SUBJECT: FAP Route 317 (US 24 /150)
Project ITS-0217 (101)
Section D4 ITS SYSTEM 2007
Peoria & Tazewell County
Contract No. 68694
Item No. 299, June 15, 2007 Letting
Addendum A

NOTICE TO PROSPECTIVE BIDDERS:

Attached is an addendum to the plans or proposal. This addendum involves revised and/or added material.

1. Revised page i of the Table of Contents of the Special Provisions.
2. Revised pages 3 and 11 – 22 of the Special Provisions.
3. Added pages 50 – 52 to the Special Provisions.
4. Revised sheet 1 of the Fold-Up Plans.
5. Added sheet 27A to the Fold-Up Plans.

POLE MOUNTED EQUIPMENT CABINET, TYPE C DETAIL

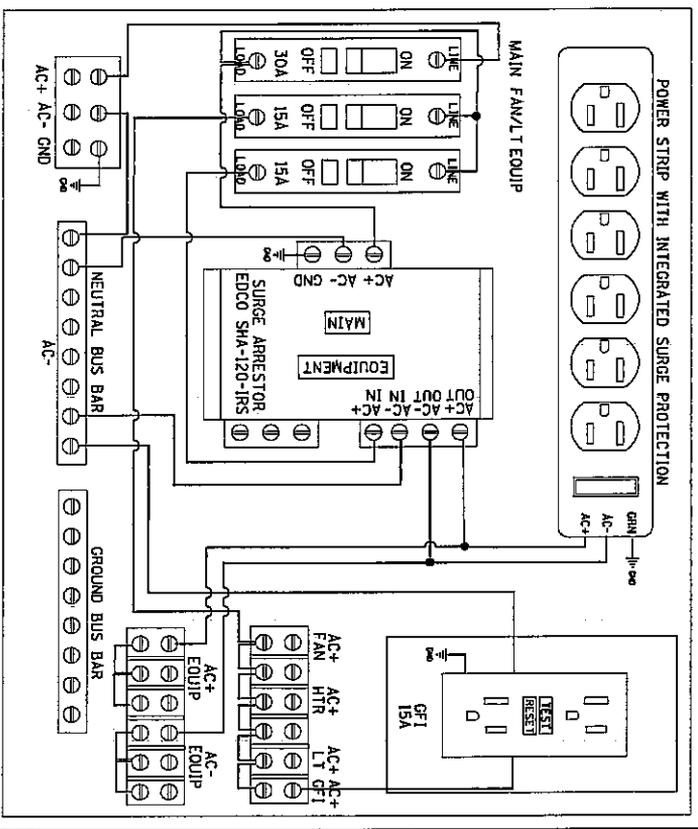
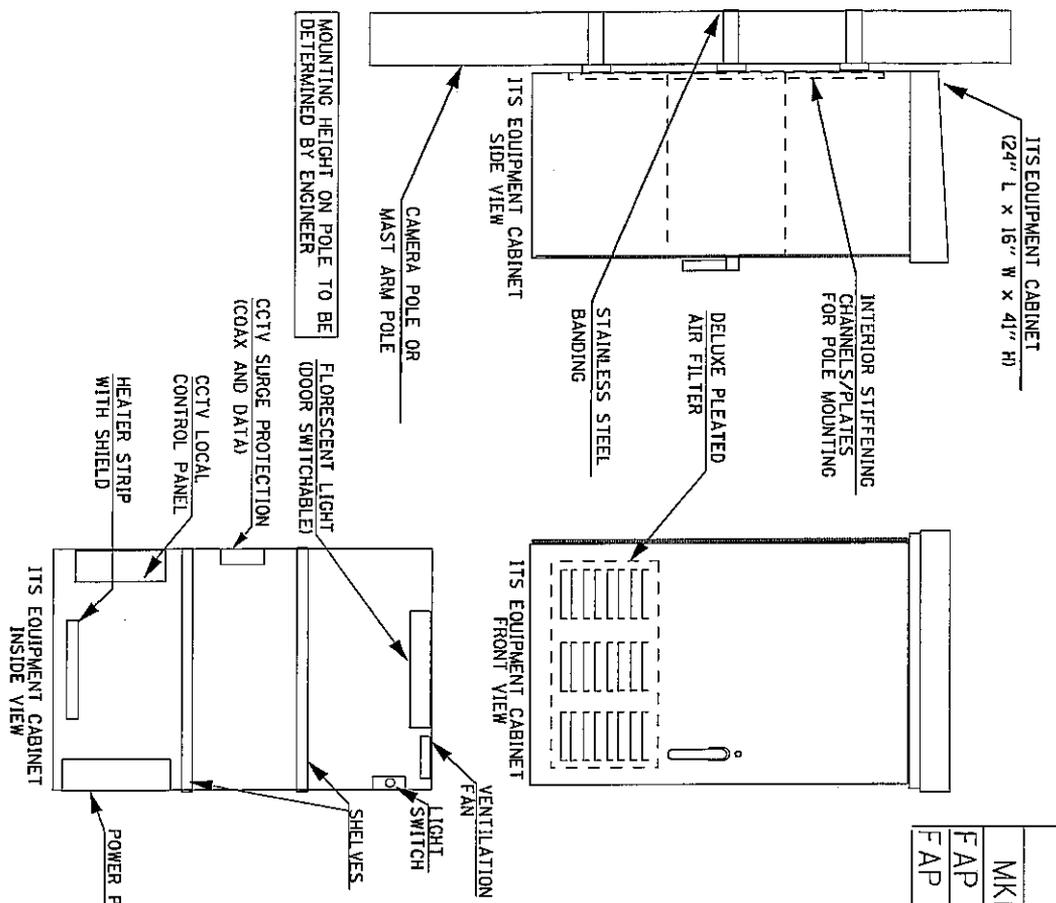
NEW SHEET

1. THE ITS EQUIPMENT CABINET SHALL BE A NEMA TYPE 3R CABINET WITH MINIMUM OUTSIDE DIMENSIONS OF 41" (H) X 24" (W) X 16" (D). THE CABINET SHALL BE CONSTRUCTED FROM .125" THICK ALUMINUM AND HAVE A NATURAL FINISH.

2. THE CABINET SHALL BE FURNISHED WITH TWO ADJUSTABLE HEIGHT SHELVES, A THREE POINT LATCHING MECHANISM WITH NYLON ROLLERS, 0.75" DIA. STAINLESS STEEL PAD-LOCKABLE HANDLE, THREE POSITION DOOR STOP (90, 120, 180 DEGREES), NEOPRENE DOOR GASKET, DOOR LOUVERS, OVERHANG VENT SLOTS, CONTINUOUS STAINLESS STEEL DOOR HINGE, INTERIOR STIFFENERS FOR POLE MOUNTING, Z CORBIN DEAD BOLT LOCK, AND ALL STAINLESS STEEL HARDWARE.

3. THE CABINET SHALL BE EQUIPPED WITH A DOOR SWITCHABLE FLORESCENT LIGHT ASSEMBLY, 15A GFI RECEPTACLE, SURGE SUPPRESSOR, THERMOSTATICALLY CONTROLLED VENTILATION FAN AND Z50 WATT HEATER STRIP WITH SHIELD, PLEXI-GLASS POWER PANEL SAFETY SHIELD, SIX OUTLET POWER STRIP WITH INTEGRAL SURGE PROTECTION, CCTV LOCAL CONTROL PANEL, CCTV SURGE PROTECTION (COAX AND DATA), AND ALL OTHER COMPONENTS REQUIRED FOR INSTALLATION.
